Reference: Copperwood Stage 2 TIA – Comment Responses

**COPPERWOOD STAGE 2
TRANSPORTATION IMPACT ASSESSMENT**

DAYTONA URBAN DEVELOPMENT CORP.
City of Lethbridge RELD
COPPERWOOD STAGE II OUTLINE PLAN

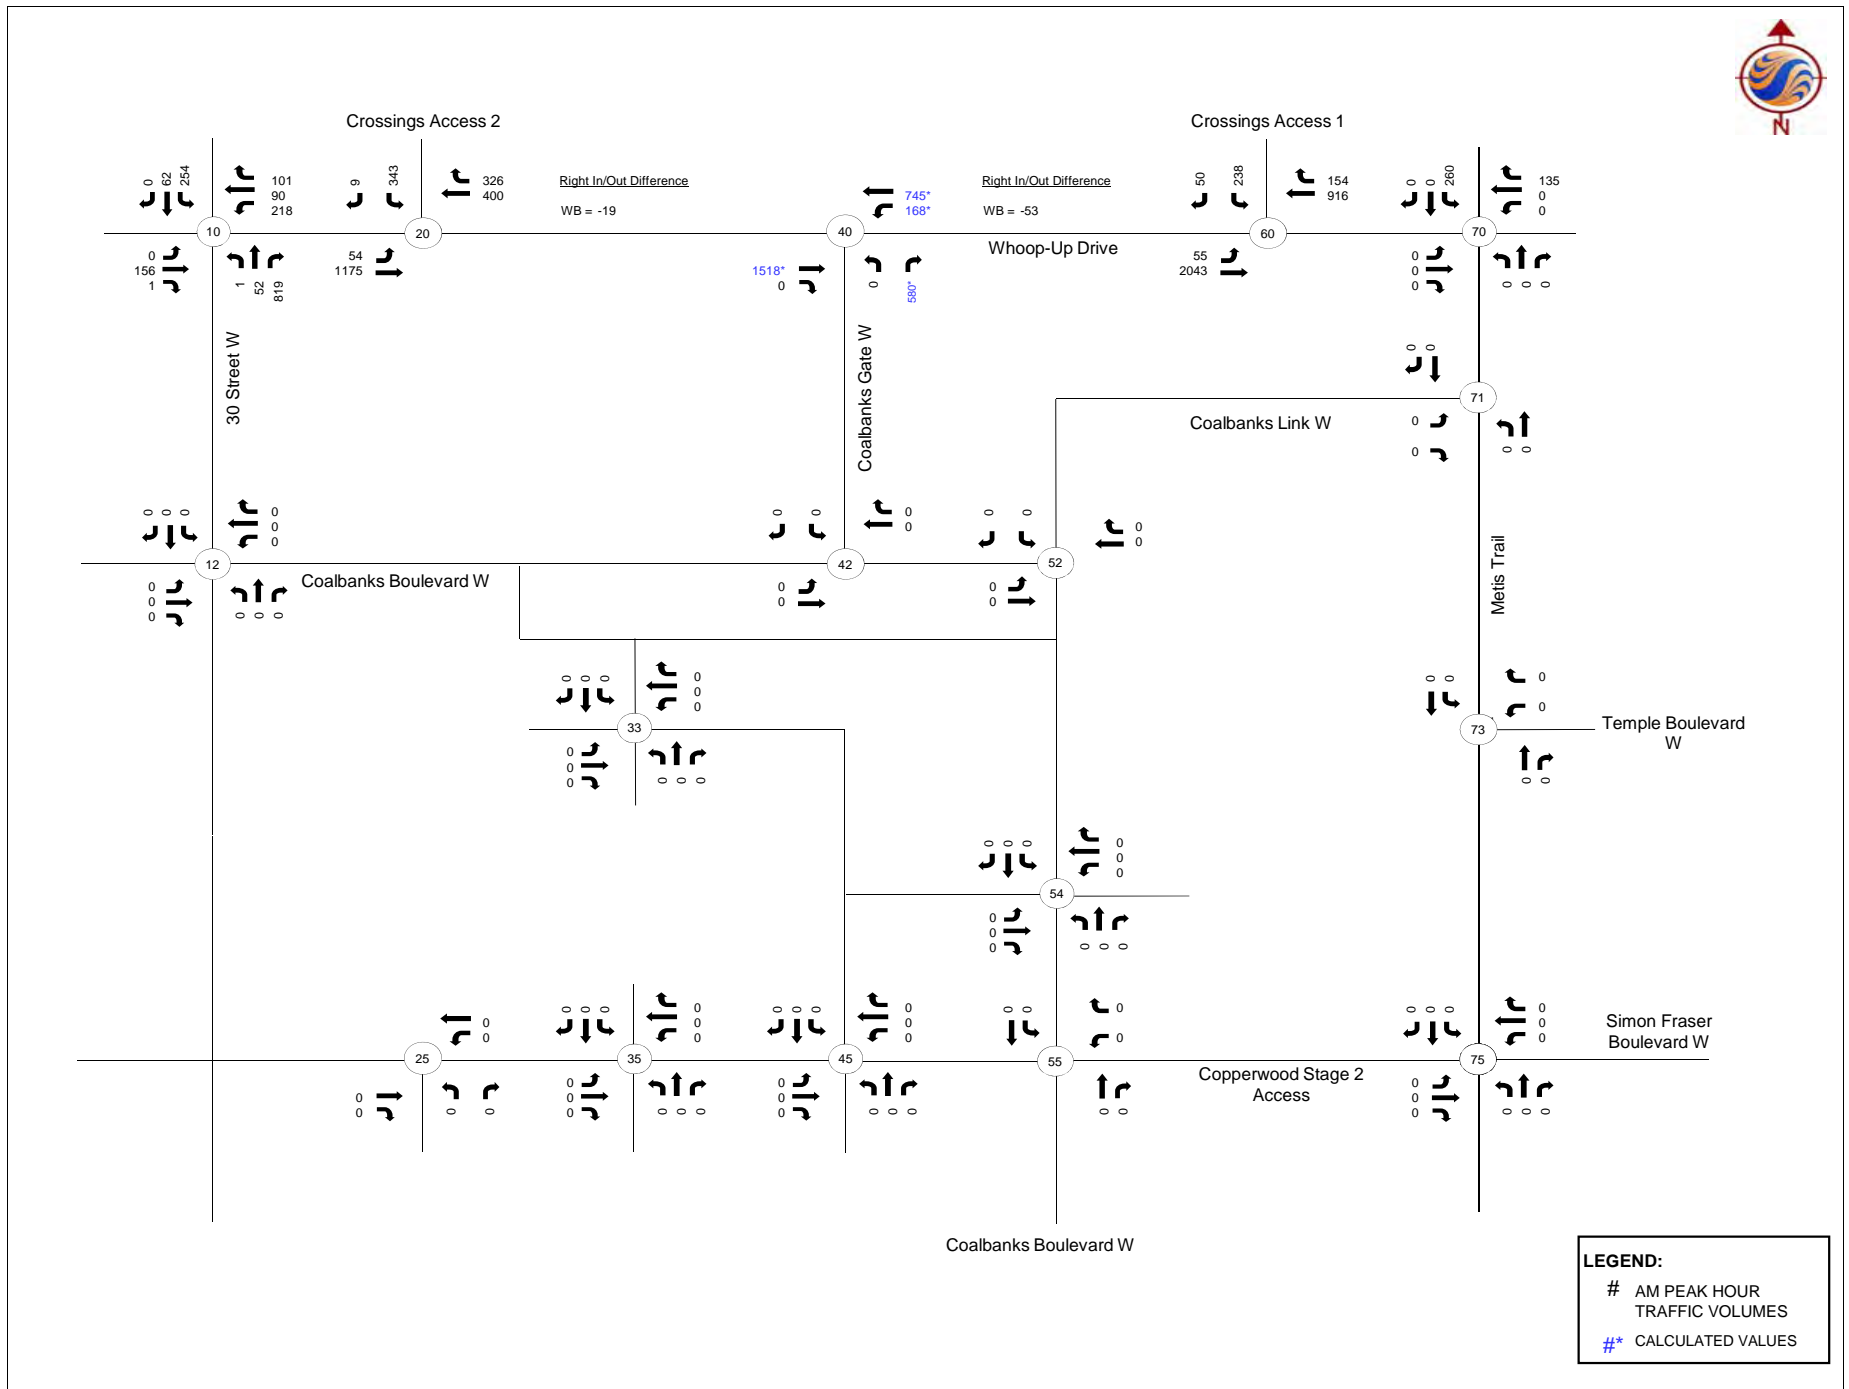
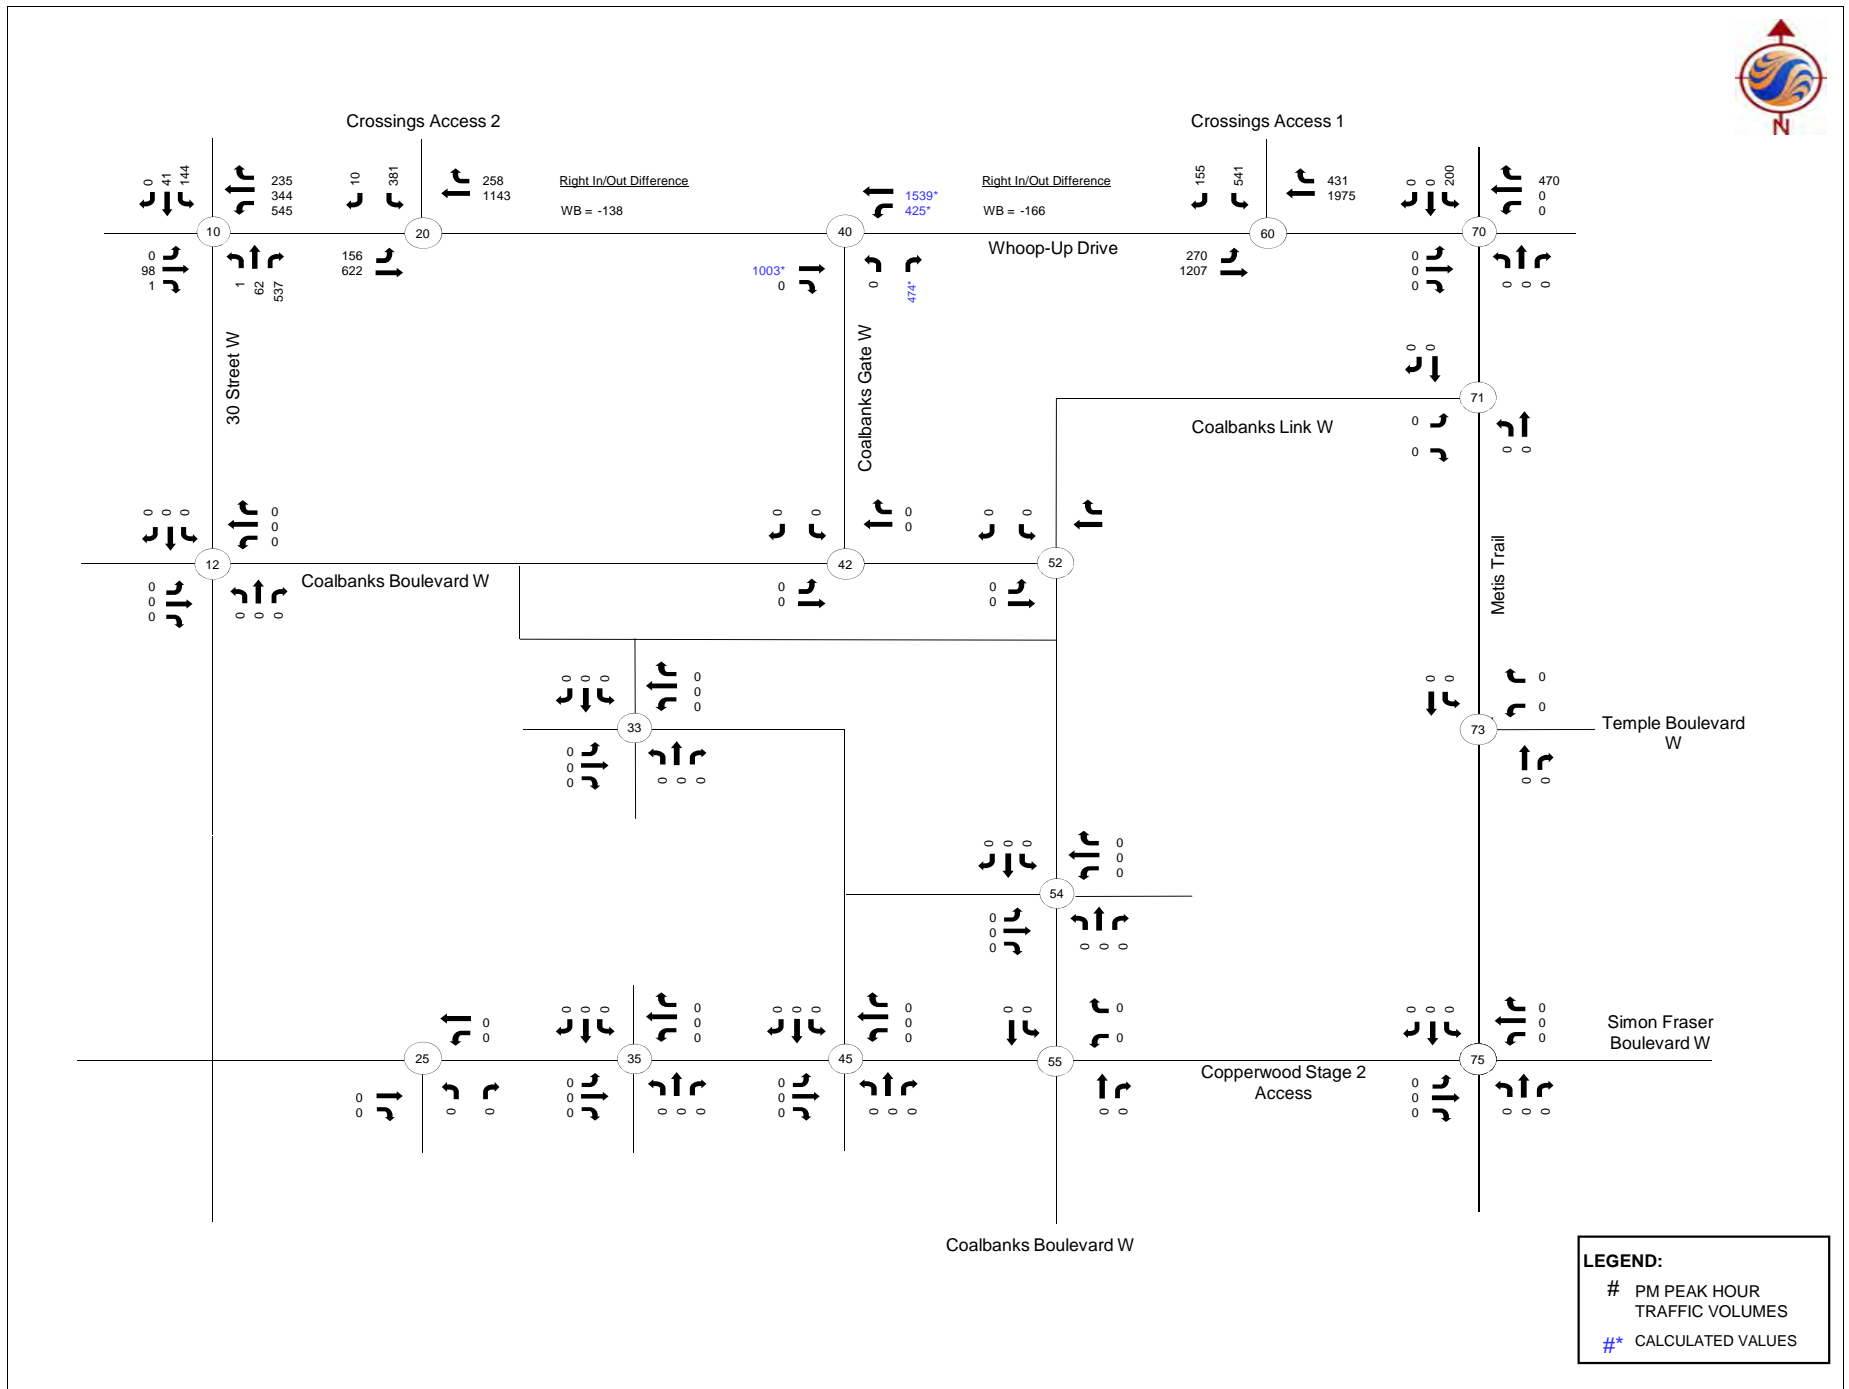
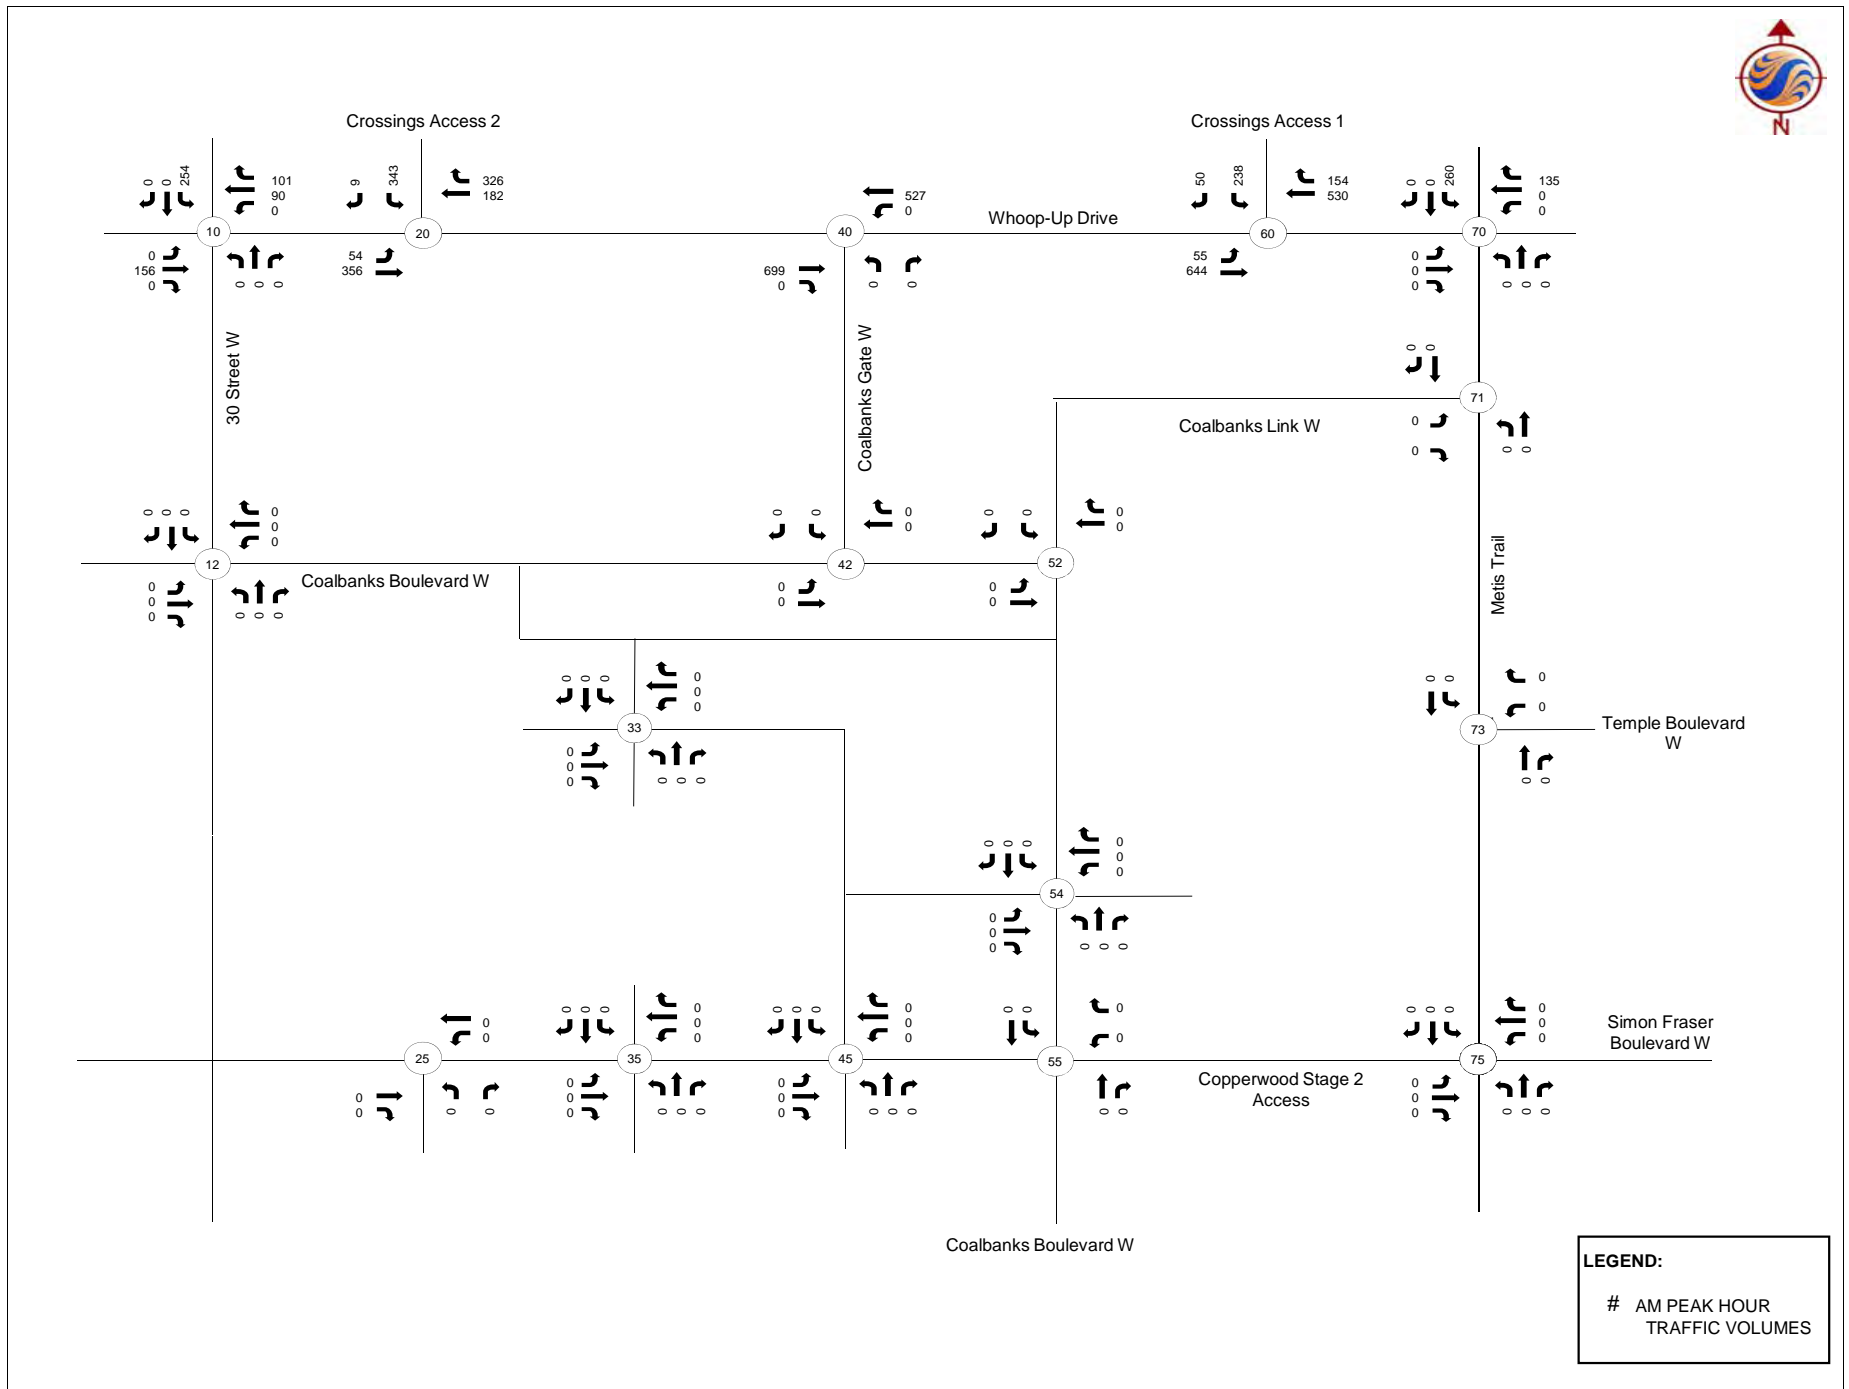
3. City’s Comment: *Figure 3.1 to 3.8 – Traffic volumes do not add up at Whoop-up Dr / Metis trail (Intersection 70), please check.*

Response: Figures 3.1 to 3.10 include information obtained from other studies (specifically the Crossings TIA – iTrans, July 2007; and the original Copperwood TIA – UMA, December 2005). These studies did not include volumes at the intersection of Whoop Up Drive / Metis Trail (Intersection 70) and therefore Figures 3.1 to 3.10 also did not include volumes at this intersection.

These volumes have been added to the updated report and are reflected in Figures 3.11 and 3.12 (background traffic volume), as well as Figures 3.15 and 3.16 which use the volumes from Figures 3.11 and 3.12 as information. The analyses for the background and post-development horizons have also been updated to include these volumes.
